Databank-Technical Bulletin

Notice of production discontinuation of the FX1S/FX1N/FX1NC series PLC main unit and certain FX2N/FX2NC series expansion products

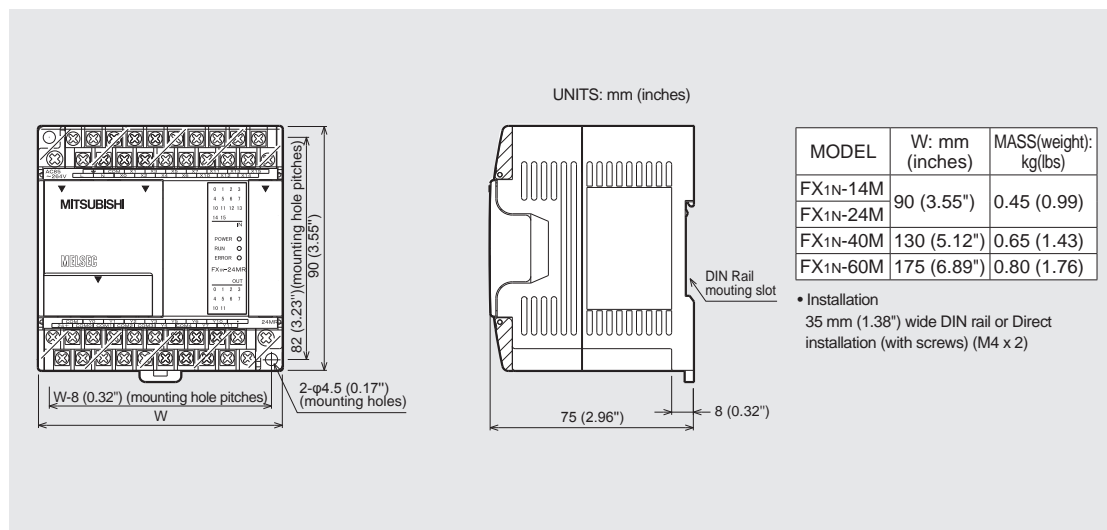
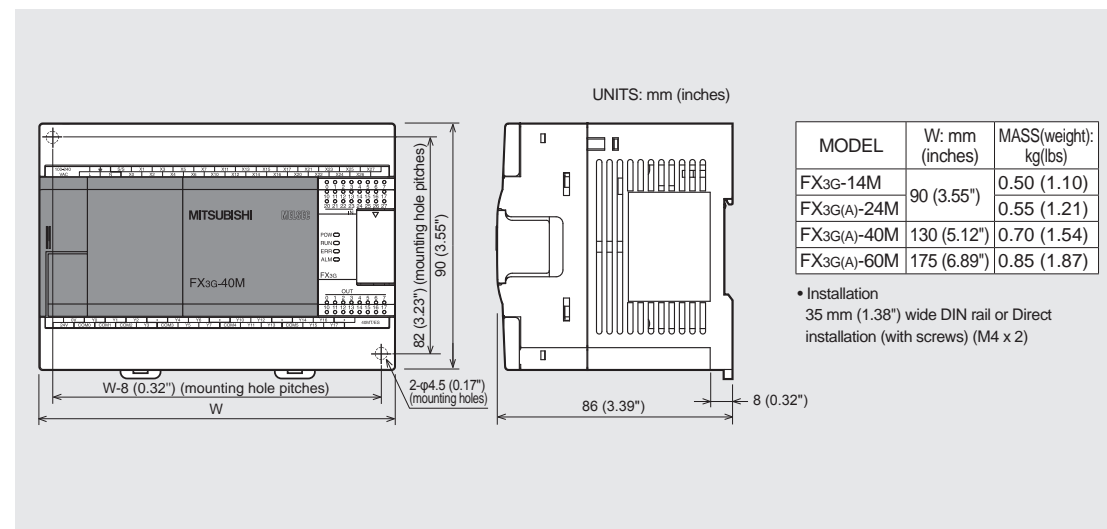
Differences: The depth of the FX3G series is larger by 11 mm compared with the FX1N series.

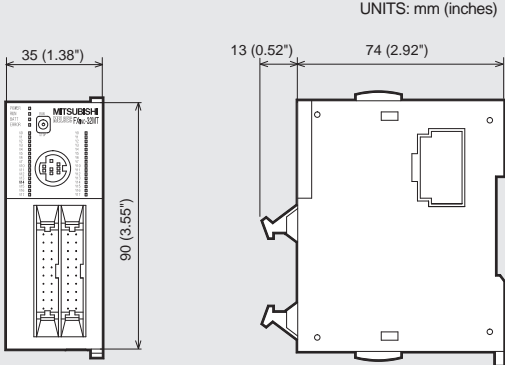
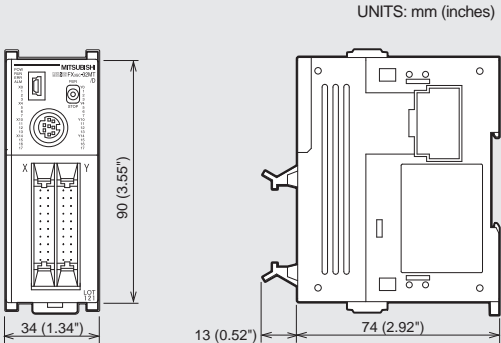
Differences: The width is differs 1mm
